## ARCHITECT'S SUPPLEMENTAL INSTRUCTIONS

<b>PROJECT:</b>	<b>Roosevelt Lofts</b> Historic Rehabilitation San Angelo, TX	<b>Report No.</b>	<b>Four (4)</b>
<b>OWNER:</b>	<b>Overland Property Group</b> 234 N. Santa Fe Ave, Suite A Salina, KS 67401	<b>Date</b>	<b>May 29, 2024</b>
<b>CONTRACTOR:</b>	<b>MCP Group</b> 3501 SW Fairlawn Rd. Topeka, KS 66614	<b>Architect's Proj No.</b>	<b>22-3281</b>
		<b>Contract For:</b>	General Construction Mechanical, Electrical

**A2.4**

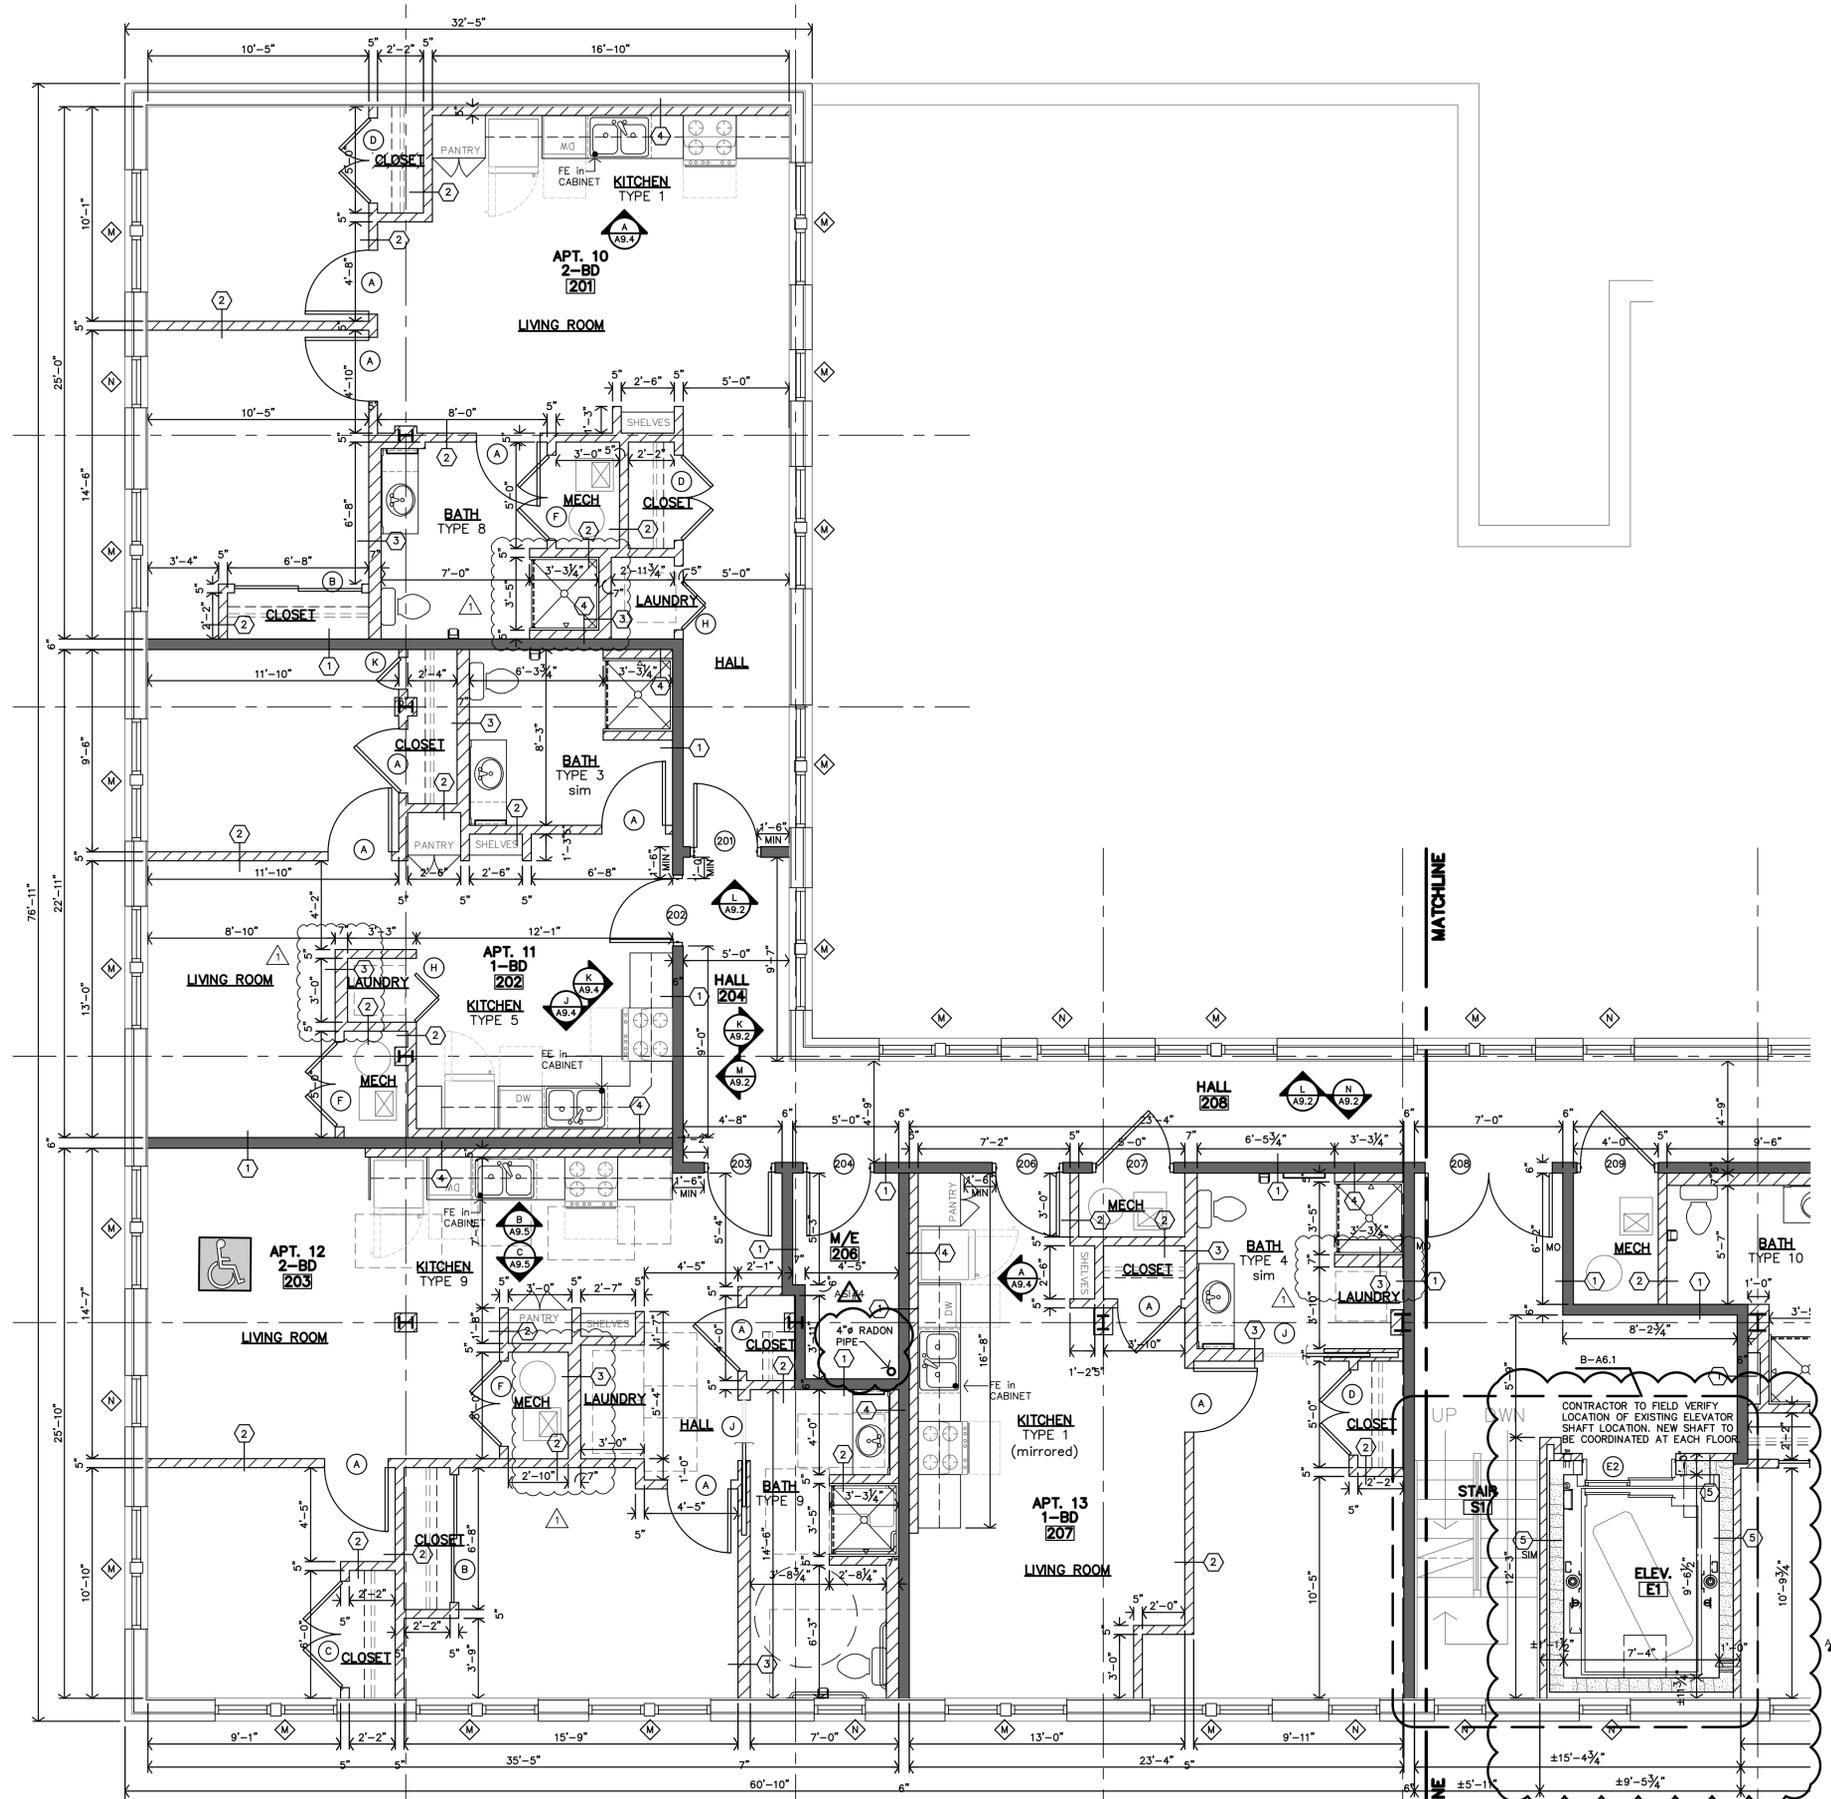
- ii. Sheet A2.4 – Added radon pipe in Mechanical Closet at Apt. 6 (#122).
    - iii. Sheet A2.5 – Added radon pipe in M/E #206.
    - iv. Sheet A2.6 – Added radon pipe, buried in wall behind laundry, Apt. 15 (#211)

**A** AREA B THIRD FLOOR PLAN  
1/4"=1'-0"

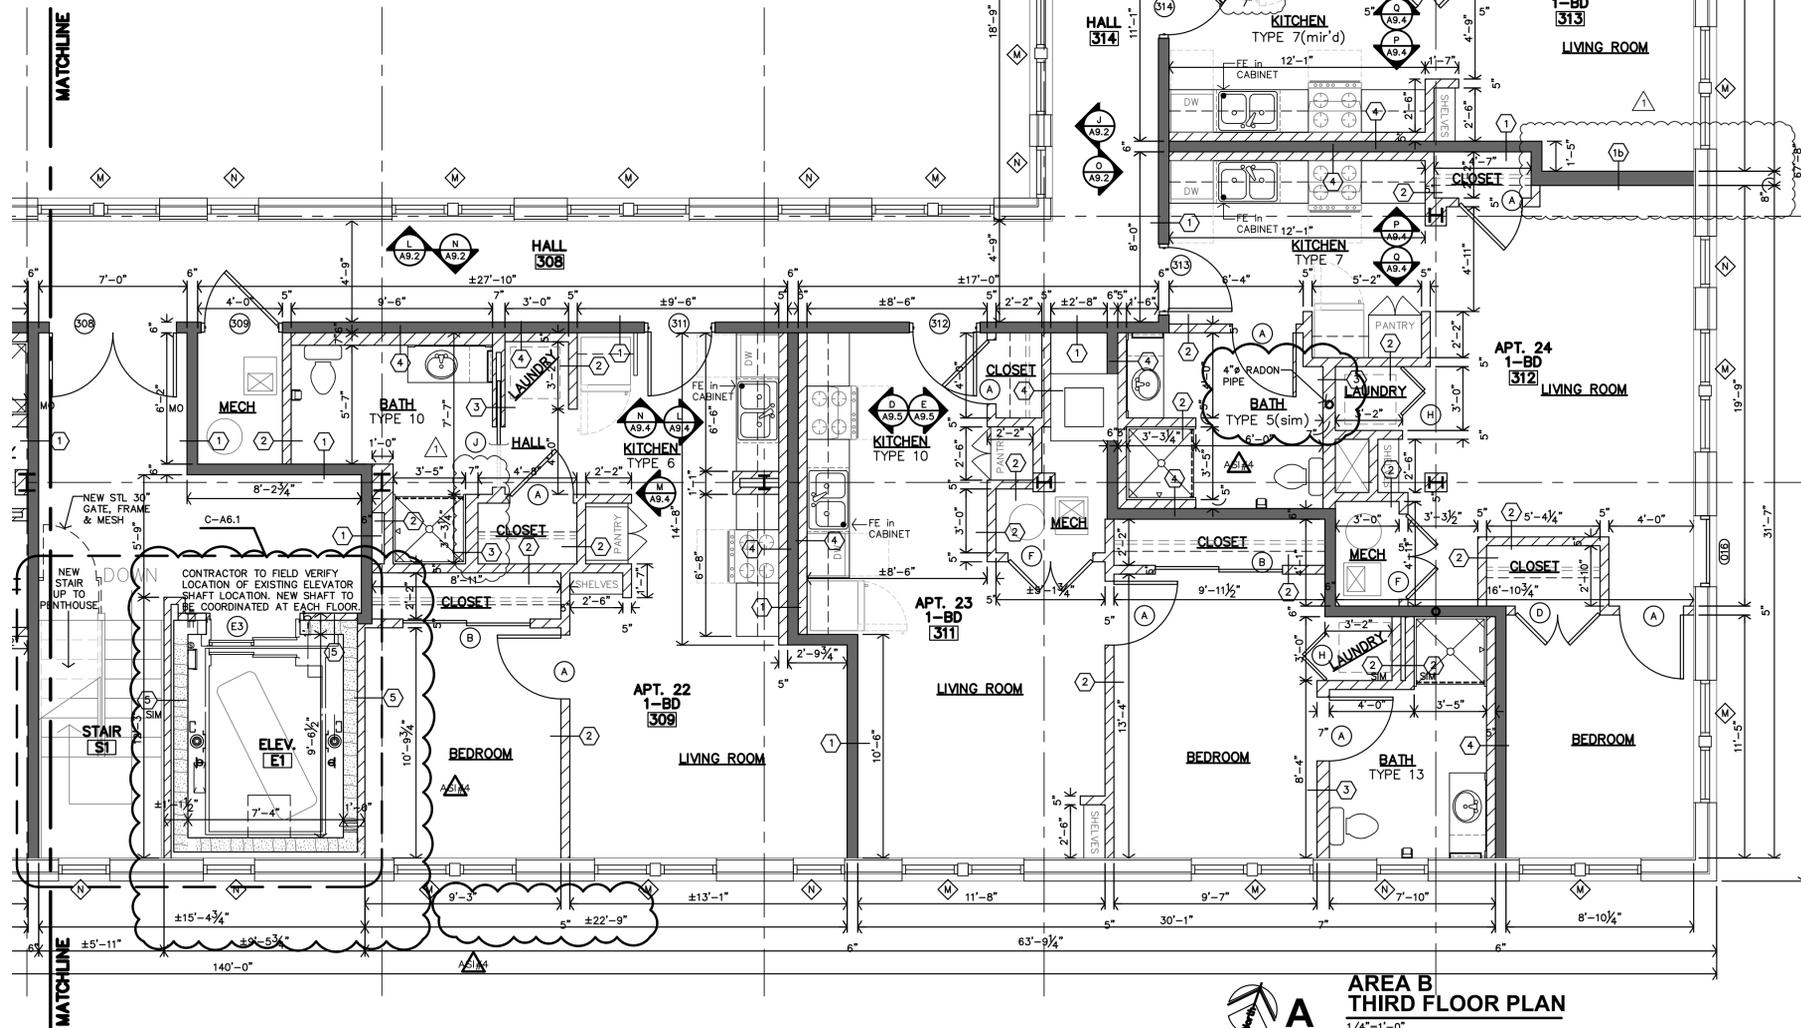
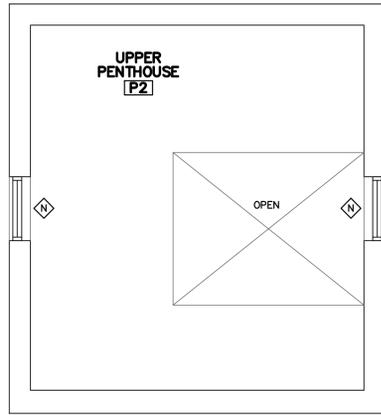
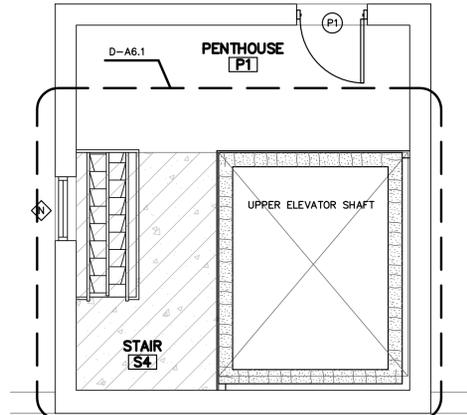
- v. Sheet A2.7 – Added radon pipe in M/E #306.
    - vi. Sheet A2.8 – Added radon pipe, buried in wall behind laundry, Apt. 24 (#312)
    - vii. Sheet A5.1 – Added (2) radon pipe penetrations at the roof
